SUBJECT: Ayrburn Farms . Mill Stream  
Floodway . Preliminary  
Assessment

Job No.: 000178

Reference: FR-15-05-07-GMD-  
000178.DOCX

**+ AYRBURN - DRAFT CONCEPT**  
AYRBURN FARM DEVELOPMENTS LTD  
BDG REF: 2514-SK05 - SCALE = 1:3000 T A3 - 12 FEB 2015

**Figure 2: Indicative Typical Floodway Cross Section**

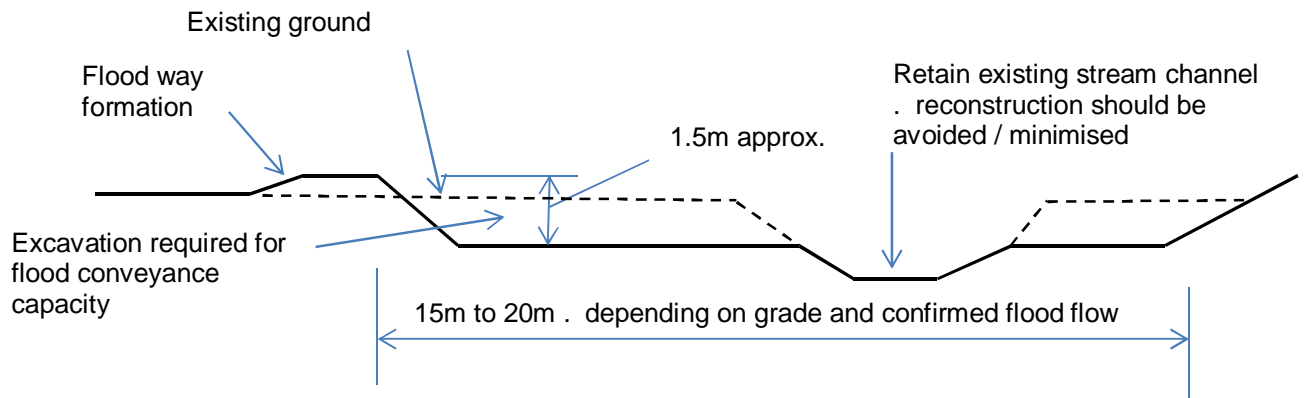
Where Mill Stream enters the site the existing channel is too narrow - a widening, probably in combination with a low bank to deflect water from flowing over the lots . a typical section is shown in Figure 2 below. Most of the floodway width could be used for walkways and selected planting such as grouped tall grasses, generally on the batters, with occasional trees provided / retained to enhance the aesthetic appearance. Species that are invasive and obstruct the floodway would be avoided.

Figure 5: Primary and Secondary Bridge Options

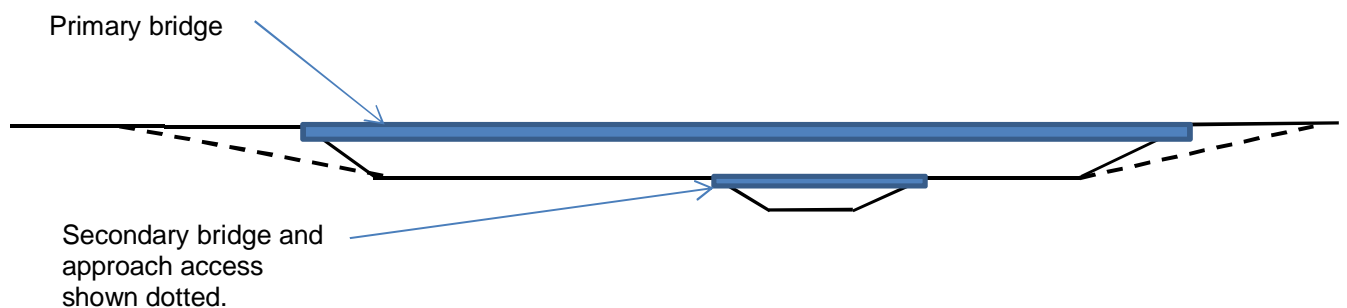
1. Primary Access - 20m long / 2 lane bridge with deck level approximately 2.5m above stream invert and spanning the width of the floodway. See Figures 4 and 5 below. A single primary bridge would be needed to provide all weather access from the west side of the development to Lake Hayes Arrowtown Road for emergency services and residents access during major flood events.
2. Secondary access . low level bridges very similar to the existing bridges across the stream channel with the deck level at existing top of bank level.

Figure 6: Residential Floodway

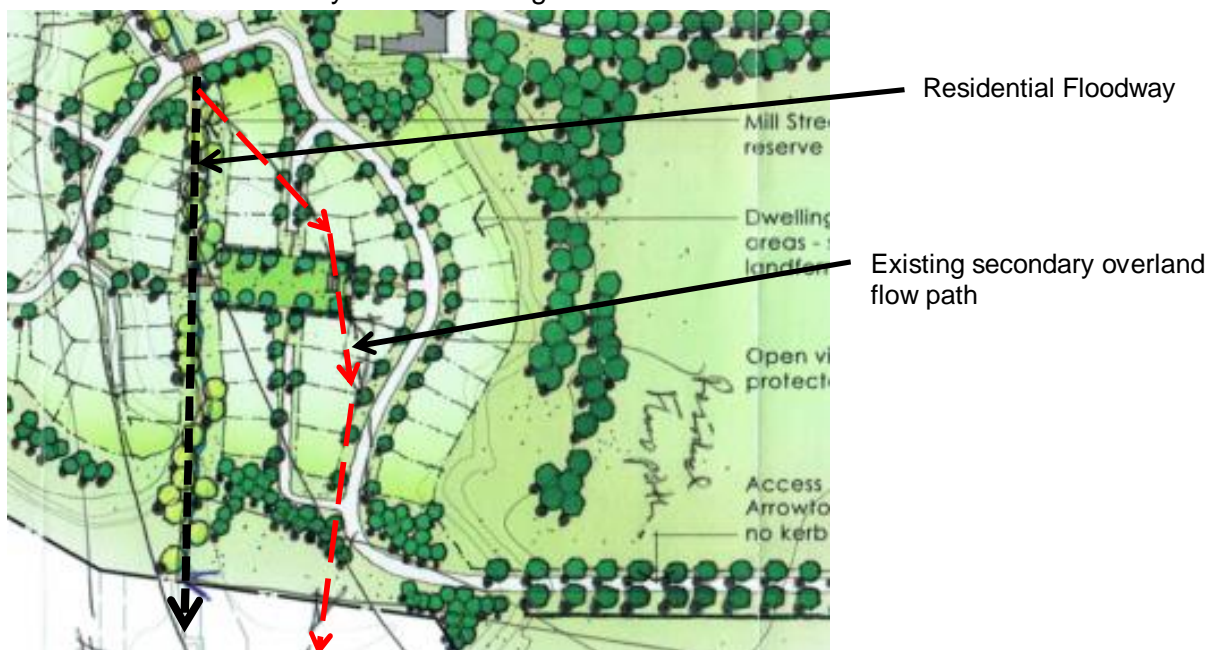
The residential floodway would be constructed in a similar form to that indicated in Figure 2. The secondary overland flow path in Figure 6 would be cut off and all flow confined to the residential floodway. Picking up all the overland flows off the common area for the farmers market and village greens would be a component of the design for the Primary bridge site.

When the water reaches the southern boundary the floodway would be carrying the combined flow from upstream and therefore a transition back to the existing broad overland flow regime that exists at present would require some consideration at the boundary where it enters the neighbour's land downstream.
